FINAL DRAINAGE REPORT

**FALCON MEADOWS AT BENT GRASS
FILING NO. 4**

GALLOWAY RESPONSE

**PCD-ENGINEERING REVIEW COMMENTS
IN BLUE BOXES WITH BLUE TEXT**

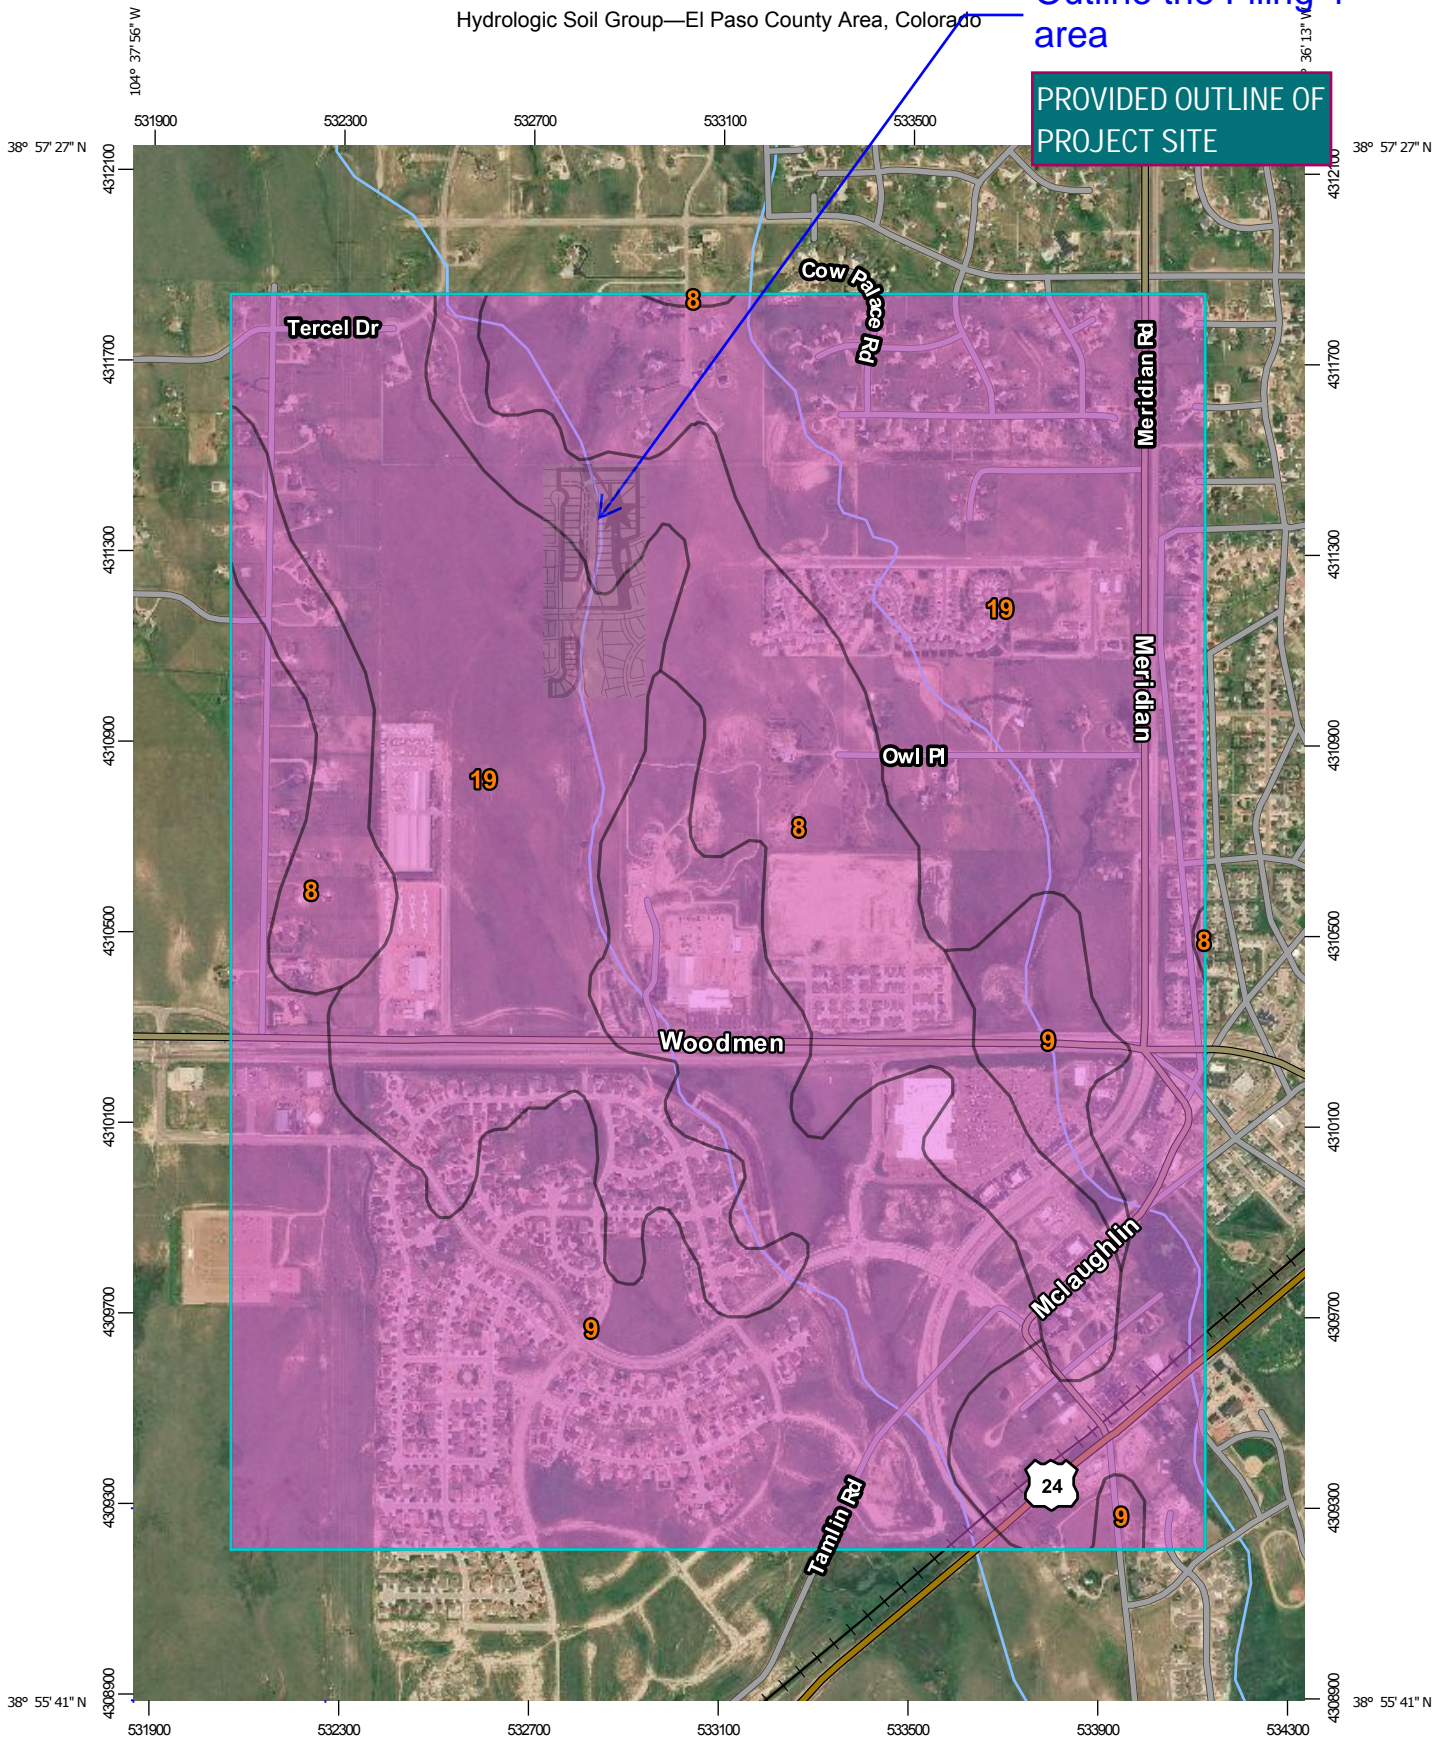
Outline the Filing 4 area

PROVIDED OUTLINE OF PROJECT SITE
